City of Carlisle, Iowa
Planning and Zoning Commission
Regular Meeting
May 17, 2021
7:00 P.M.

RE: **Carlisle Commons – Public Improvements**

RE: **Carlisle Commons – Preliminary Plat & Site Plan**

Thank you for submitting your project for review. The City is committed to assisting you with the completion of this project. FOX Engineering and the City Staff have completed the second review for the Carlisle Commons Site Plan dated May 10, 2021 and have the following comments:

REFERENCE NUMBER:	
DRAWN BY:	BK
CHECKED BY:	DB
REVISION DATE:	04/20/2021 CITY#1 05/10/2021 CITY#2 05/14/2021 CITY#3
PROJECT NUMBER:	210080
SHEET NUMBER:	C4.1

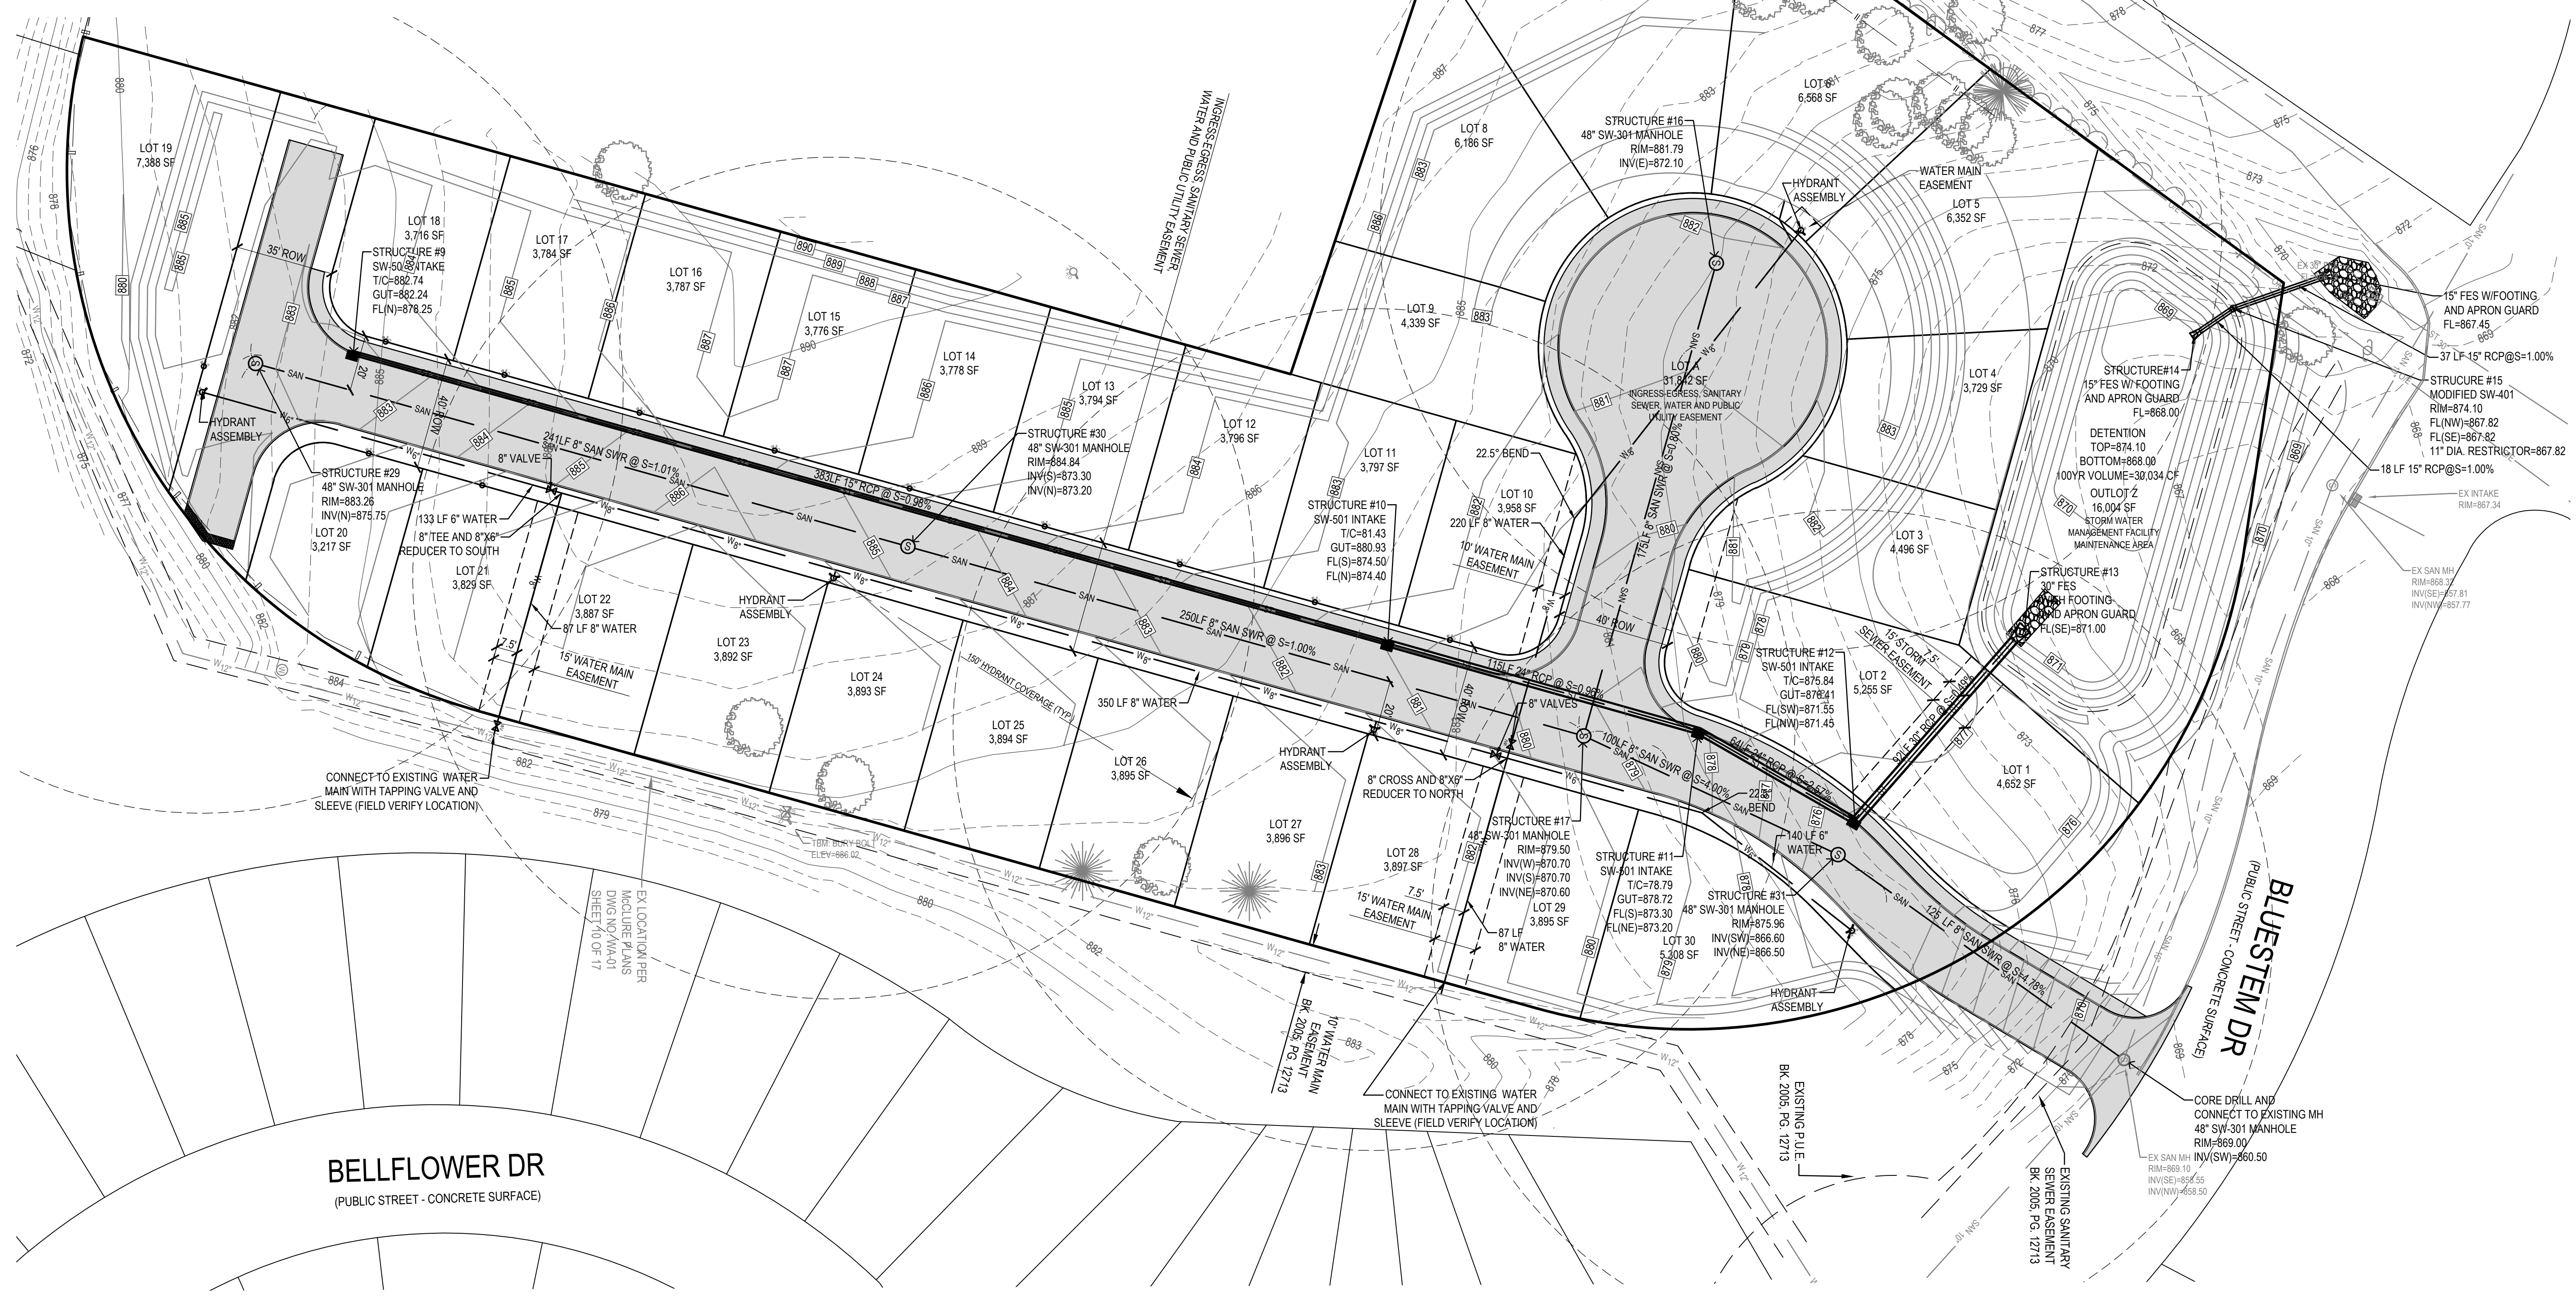
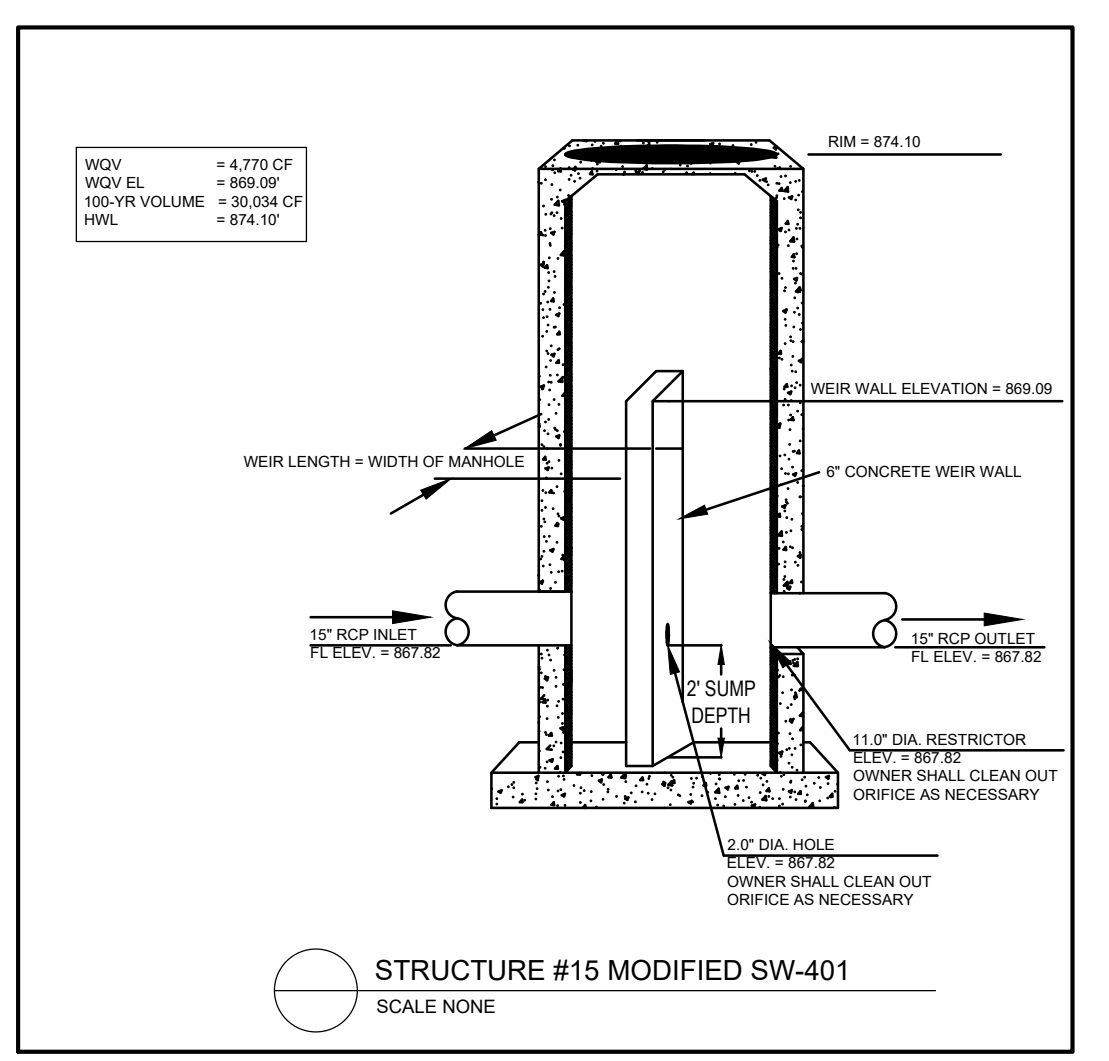
Sheet C4.1 – Utility Plan:

15. Will there be storm sewer services to the lots? The Public Improvement plan details show a storm sewer service to each lot, but nothing shown on these plans (and storm sewer is not called out as public). Please revise the plan as necessary.
16. Please see the attached markup of sheet C4.1. Please provide an additional structure (or move the proposed manhole) at the property line and 15" storm sewer at 1% (to the ditch) that the future contractor can remove/replace. If the Developer has another idea that will be compatible with the future Scotch Ridge Road project, please present for consideration.
17. Please dimension the width of the overflow for the detention areas.

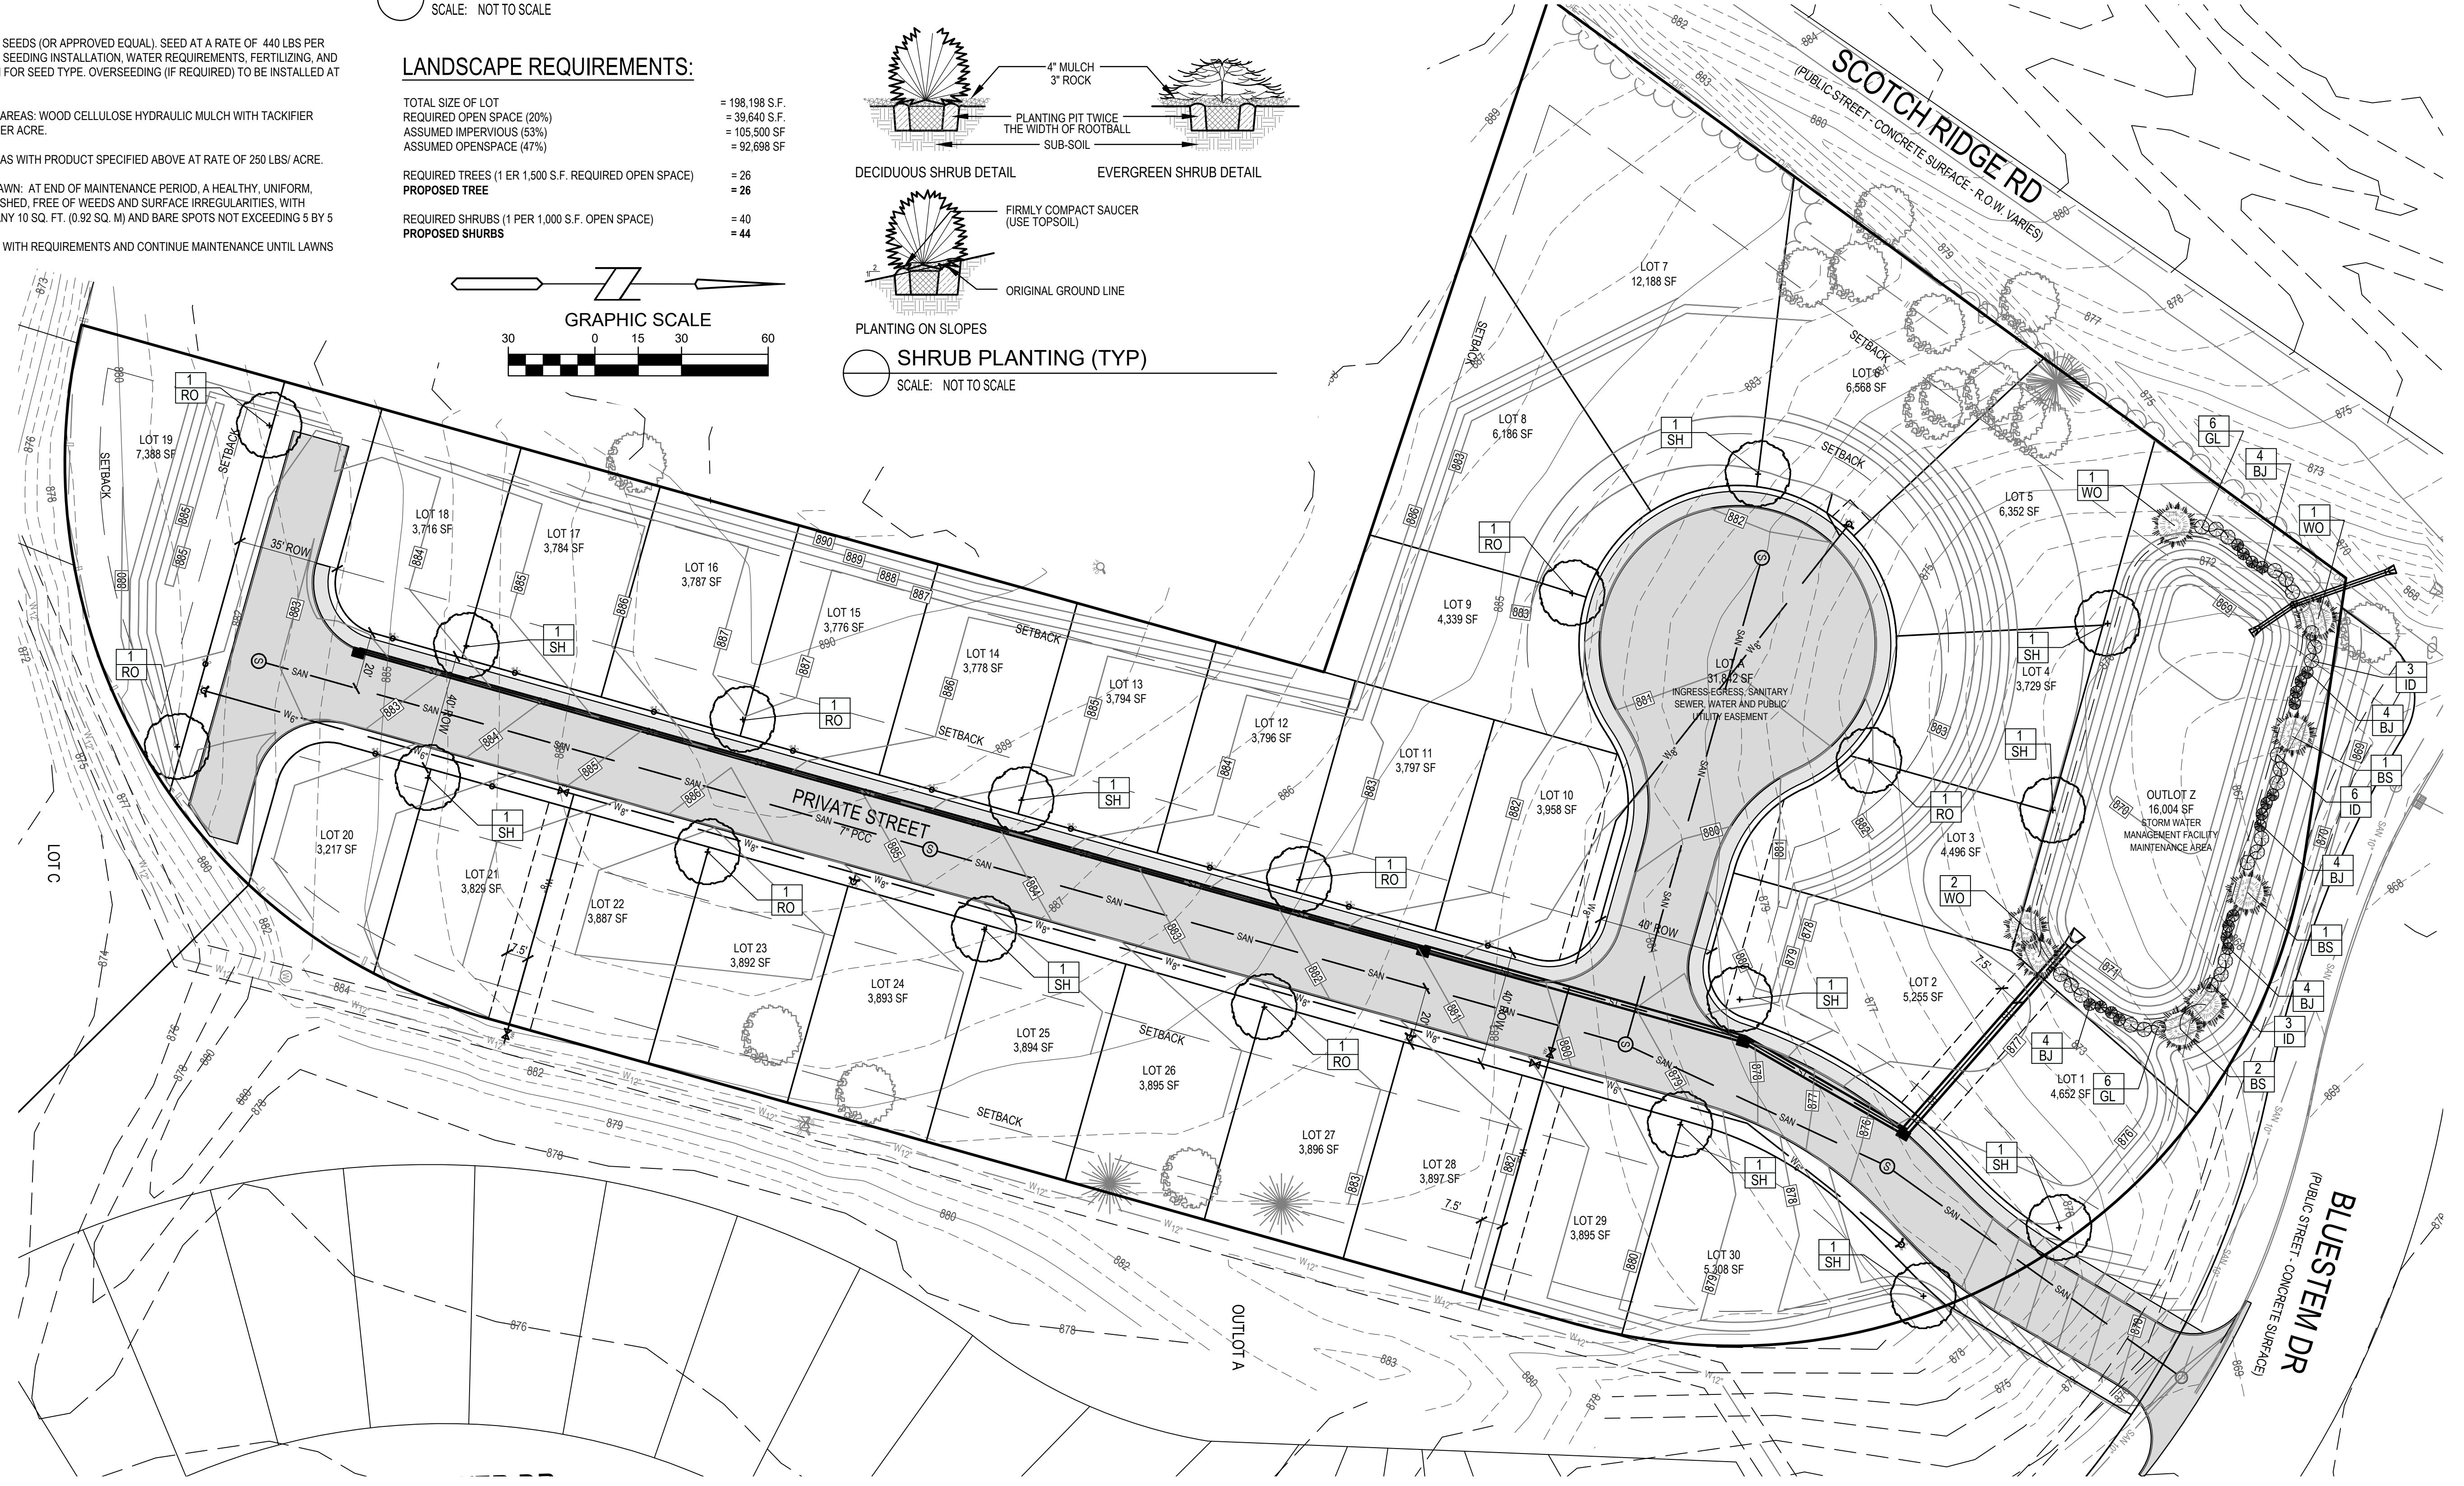
Landscaping:

21. Please clarify how the site will be seeded/stabilized. I couldn't find this anywhere on the site plan.
22. No trees/shrubs are being provided as part of the site plan. Please review 165.06, 5, F of the Code, specifically regarding tree/shrub count per open space area. In addition, FOX recommends providing landscaping along Bluestem Drive similar to what the Danamere Townhomes did to help blend the sites. A landscaping plan shall provide all information necessary per Chapter 165.06.
